SUNSET ROAD CLIFF ISLAND
109B-D-11

AMENDMENT TO APPLICATION FOR PERMIT 13 1939

STATEMENT ACCOMPANYING APPLICATION FOR BUILDING PERMIT TO COVER ALTERATIONS
IN THE COTTAGE OF ELEANOR WILSON ON SUNSET ROAD, CLIFF ISLAND

(A) APARTMENT 117
APPLICATION FOR PERMIT Permit No. 2082

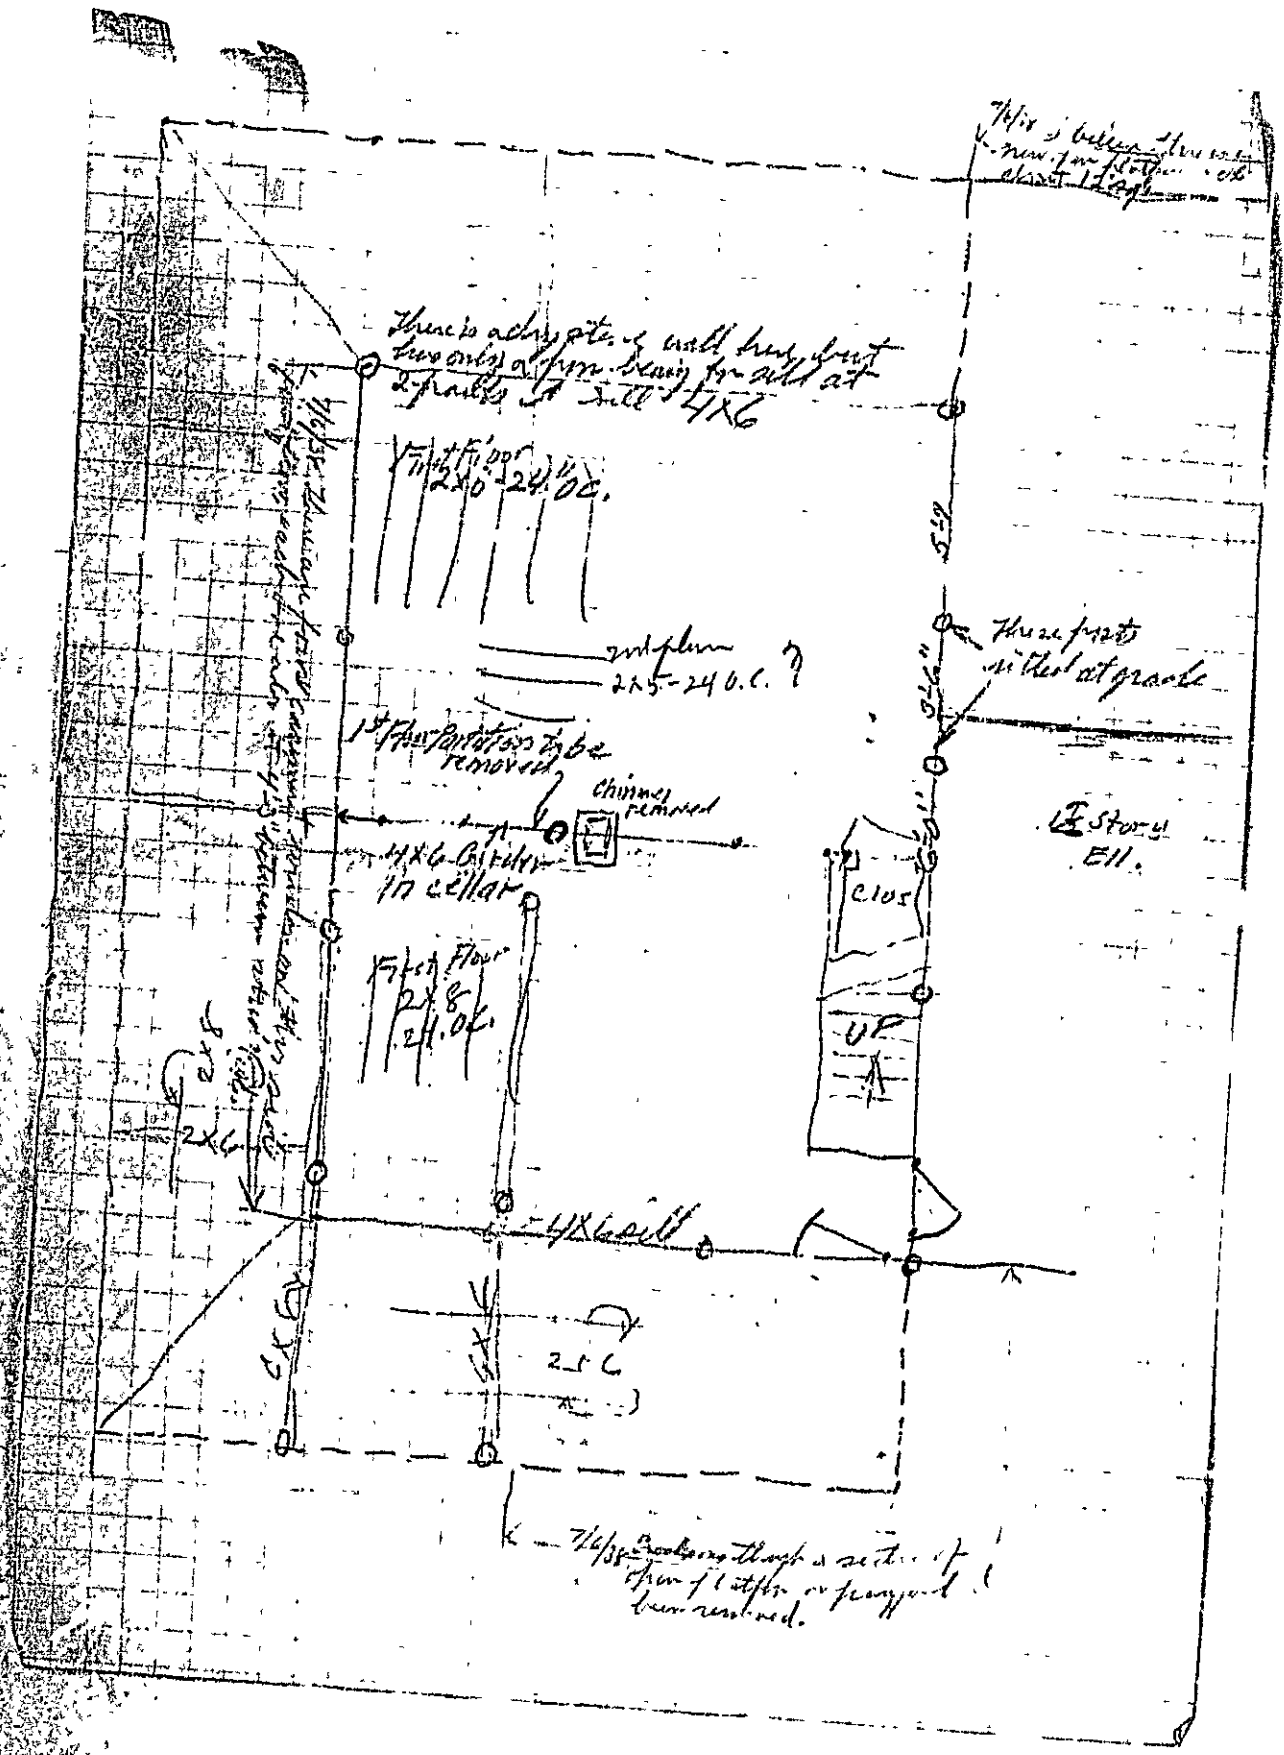
This is below the main
new floor plates... ok
about 12' up

There is a dry pt. of wall here but
two only a 1/2" beam for sill at
2-prails at sill 4x6

These parts
in the at grade

1st floor partitions to be
removed

Chimney
removed

1/4" beam along the side of
them if better or stronger
be removed.

First Floor
Sunset Ave.

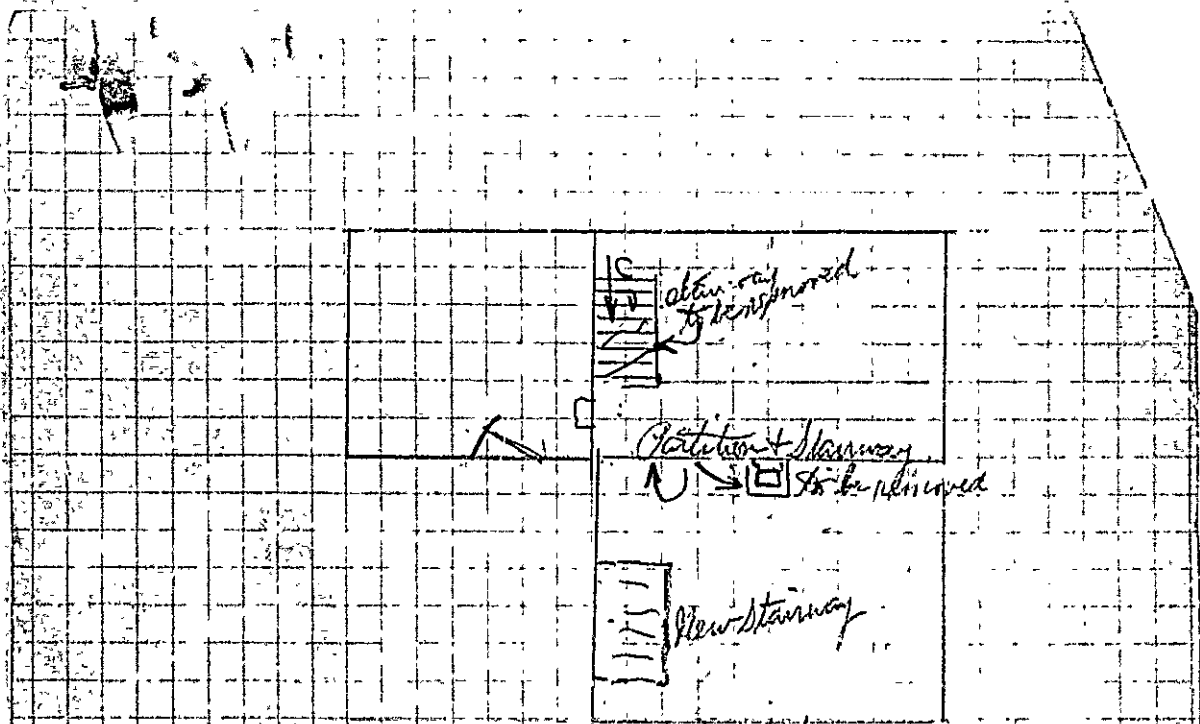
A.C.K.
Do you
know what
this is about?
mm

Looking over the job
the floor timbers run across
ways of the building of
Miss Wilson. I think the
down stairs partition is a
help in holding the up
stairs floor. because there
is a sag in the floor either
side of the down stairs
partition. I don't know what
would be best.

From your letter concerning the proposed alterations in the cottage of Miss Eleanor Wilson on Sunset Road, Cliff Island, I should judge that the partition, 18 feet of which you intend to remove, must be a supporting partition. If this is the case, a rather heavy beam would be necessary to support the overhead work on the 18 foot span. When the span of a wooden beam becomes more than about eight feet, the strength of the beam reduces very rapidly. If any very substantial floor areas above are to be supported by this beam, it may be necessary to go to a light steel beam, unless the owner is willing to be satisfied with a very heavy wooden girder or the depth of a truss which would interfere perhaps with headroom in the new living room.

I suggest that you get some person capable of figuring out the amount of weight that will likely come upon this beam and of figuring the size of beam or other supports necessary and have him design the supports for the owner.
